MODIFIED FRAMING IN No 1 HOLD.

HARLAND & WOLFF LTD.
BELFAST

No. 1354.

TITLE *mod. to framing at
fore end*

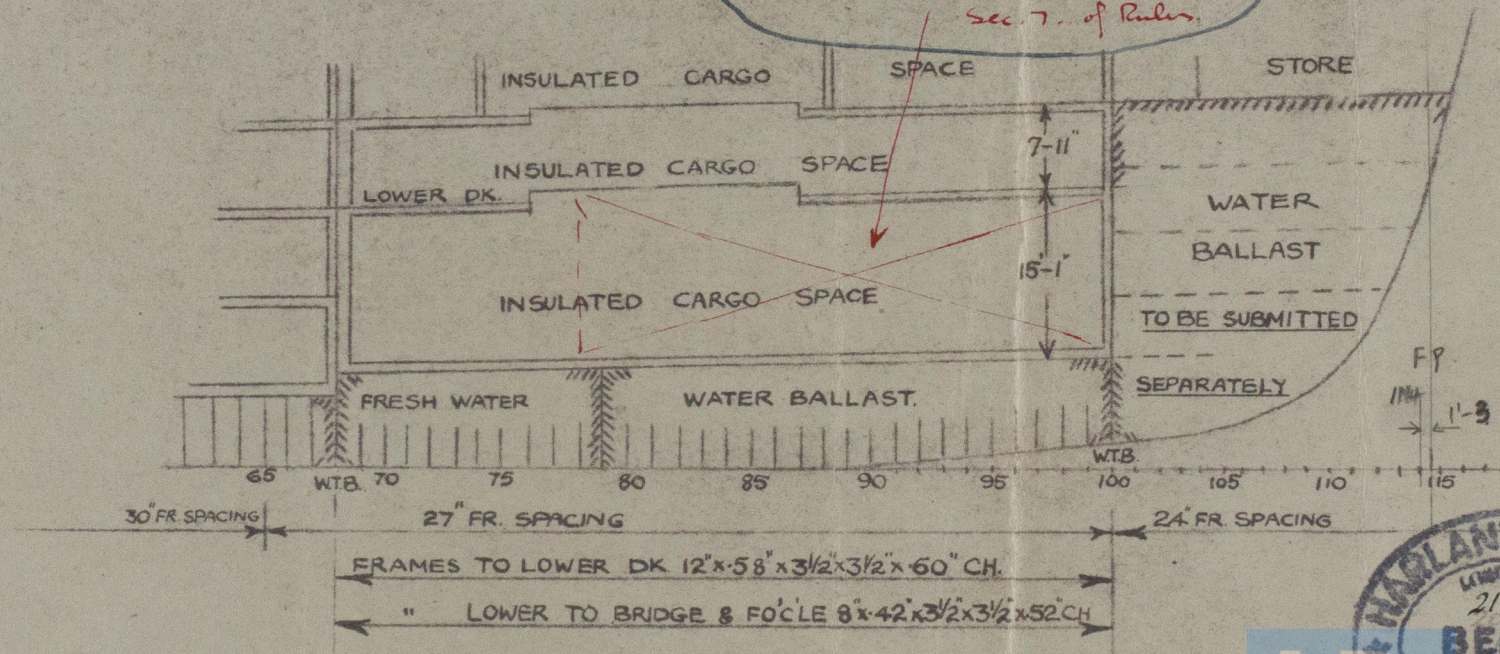
*Painting stowage to be fitted
w shell plating increased per
Sec. 7. of Rules.*

SHELL PLATING
INCREASED.
